**Environmental
Planning
Commission**

**Agenda Number: 01
Project Number: 1004167
Case #: 17EPC-40043
October 12, 2017**

Staff Report

Agent	Wooten Engineering
Applicant	Jim and Christen Schull
Request	Site Development Plan for Building Permit
Legal Description	Lot 7-A, Bosque Plaza
Location	on Coors Blvd. NW, between La Orilla Rd. NW and Bosque Plaza Lane NW
Size	Approximately 1 acre
Zoning	C-1 (SC)
Proposed Zoning	No change

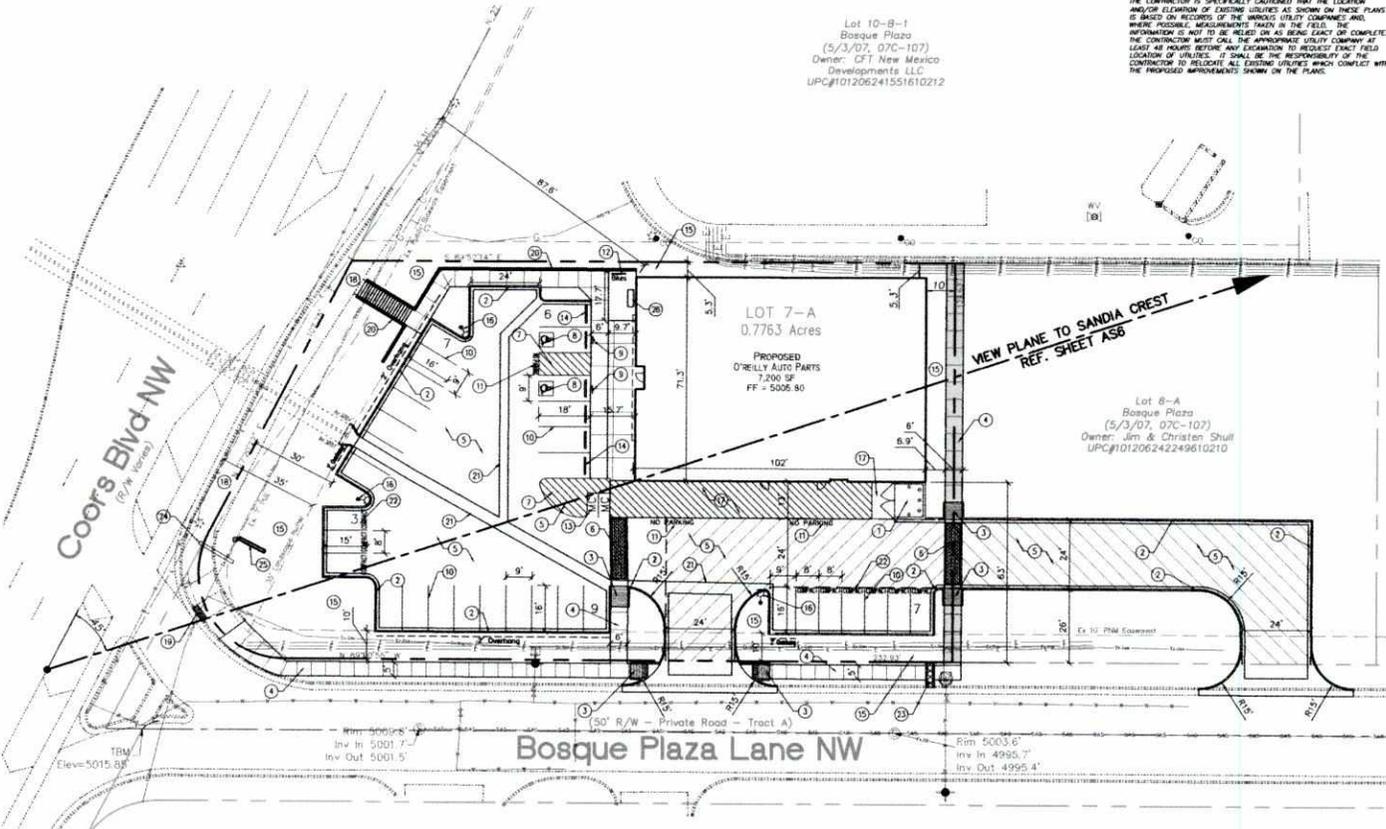
1. ADA curb ramp located at Coors and Bosque Plaza should be updated with truncated domes.
2. O'Rielly sign must be moved into the property. Coordinate with NMDOT if sign will remain in place.
3. Please provide access easement for sidewalk and drive entrance on Lot 8-A.

Retaining Wall Detail
MIS

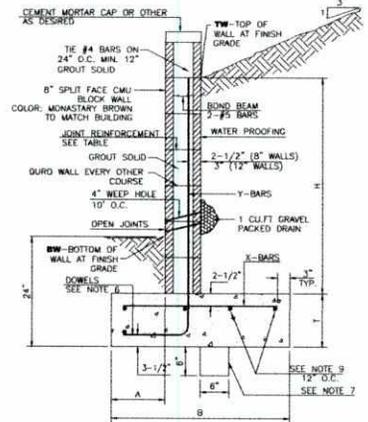
BPDS COMPLIANCE: Because the proposed retaining wall faces a public street right-of-way, the design regulations in Zoning Code 14-16-3-19, Height and Design Regulations for Walls, Fences, and Retaining Walls, apply. A face-on wall detail is needed. A wall feature from (C)(2)(a) and (b) will need to be provided.

5. Walls:
 - A. A decorative feature from (C)(2)(a) and (C)(2)(b) shall be added to the proposed wall pursuant to Zoning Code 14-16-3-19, Height and Design Regulations for Walls, Fences, and Retaining Walls.

- B. A face-on wall detail shall be provided.
6. Outdoor Seating:
 - A. A shaded patio space with outdoor seating shall be provided (Standard C-5).
 - B. Seating calculations shall be provided.

Project Number	2017004
Drawn By	RL
Checked	RL
Issue Date	September 20, 2017
Conceptual Utility Plan

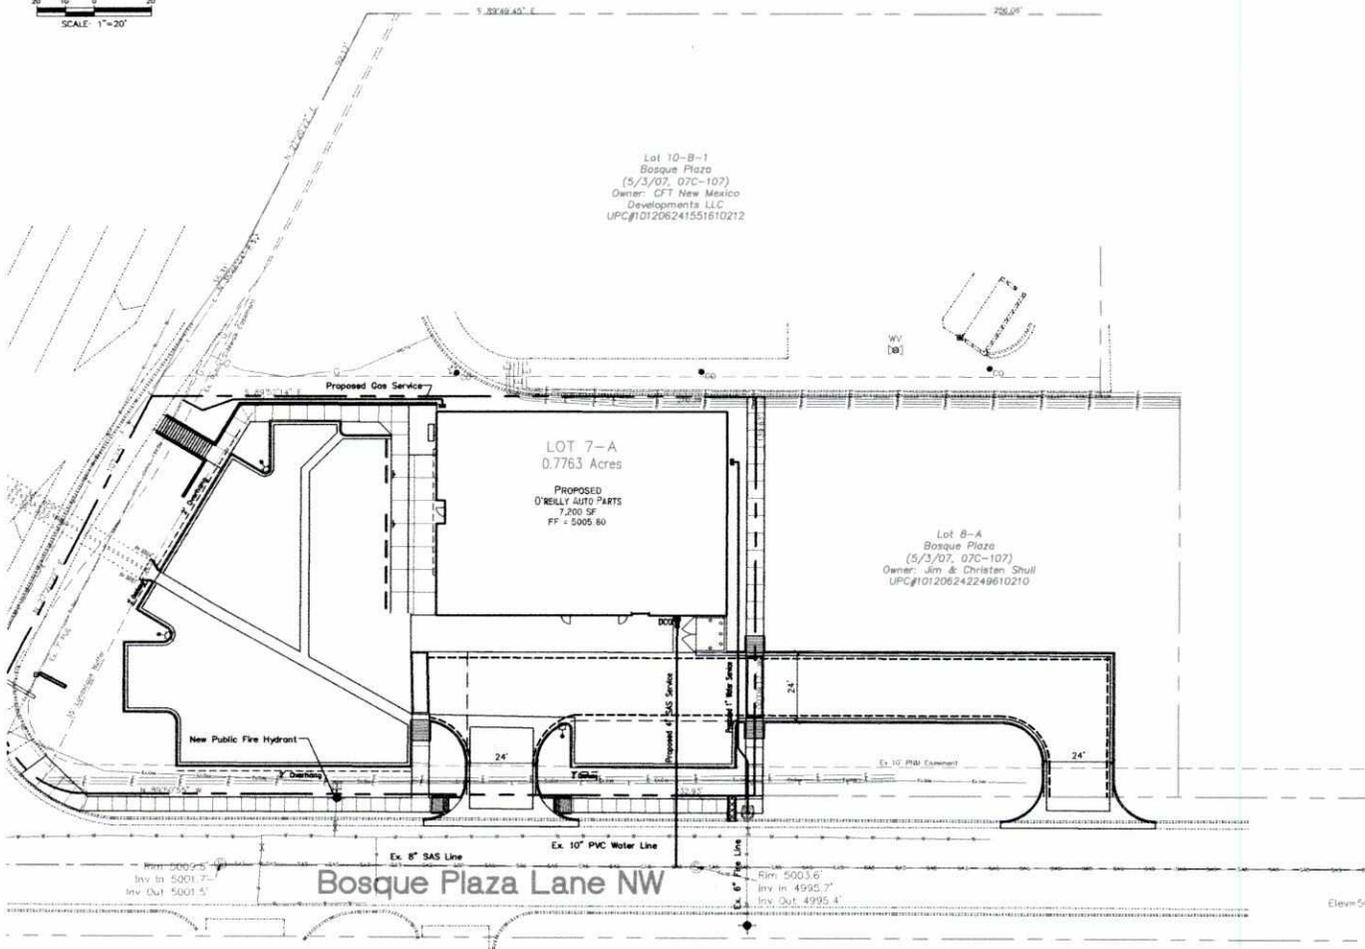
- b. Please note that the water meter box installed with project 26-7134.81-05 indicates the installation of a 1-1/2” meter service.
 - i. The proposed utility plan indicates a 1” service. The standard detail for water services groups services sizes for ¾” and 1”, as well as 1 ½” and 2”. If a 1” service is desired a new connection to the street as well as abandonment of the existing service will be required.

- c. The proposed Utility Plan indicates a new sanitary service connection.
 - i. Please note that there currently exists a sanitary sewer service stub to the property.

- d. The proposed utility plan does not indicate utilization of the existing fire line.
 - i. Please note that as the site develops if the fire line is not required then the fire line will need to be abandoned to the distribution main in the street prior to sale of service.

1 WEST EXTERIOR ELEVATION
AS.1 SCALE: 1/8" = 1'-0"

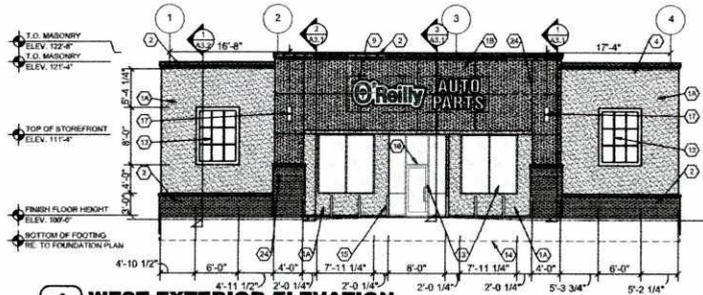
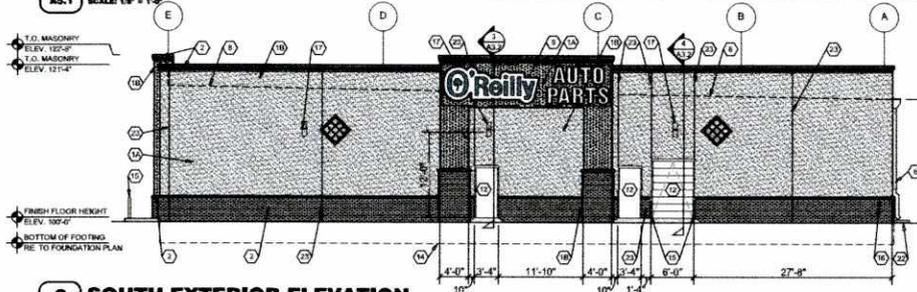
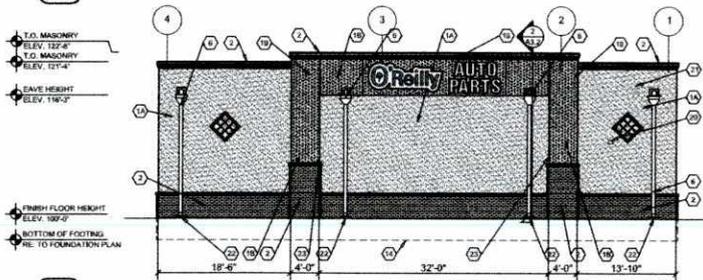
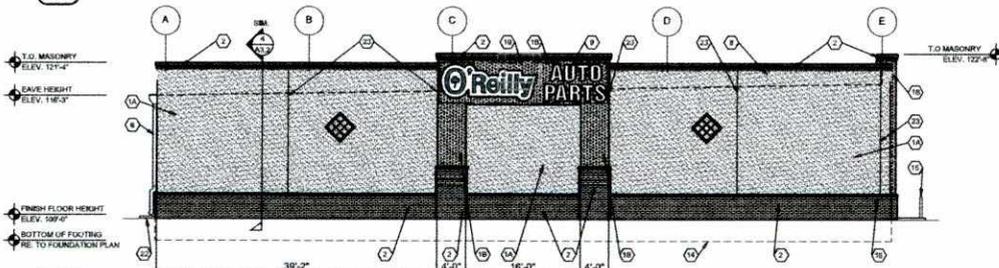
- A. Add a bullet point stating the building's highest point from the finished floor.
- B. The length of the building shall be noted as 102 feet (see Sheet SP-1.1).
